Access Compliance Report Public Rights-of-Way (Pedestrian Signals)

Main Street: VALENCIA_AVE Cross Street: VALENCIA_AVE Location: SW

ADA ID: SGAT220218174610 Signal Type: One Push Button-Non APS Overall Compliance: No Severity Scores: BTN 1: 10 BTN 2: N/A No BTN: N/A

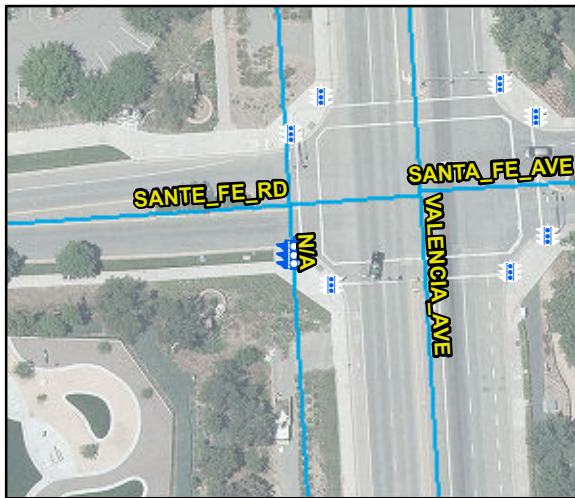
Possible Solutions: Replace Signal Push Button With APS Button.

OC Std/PROW: R403.4, MUTCD 4e.08
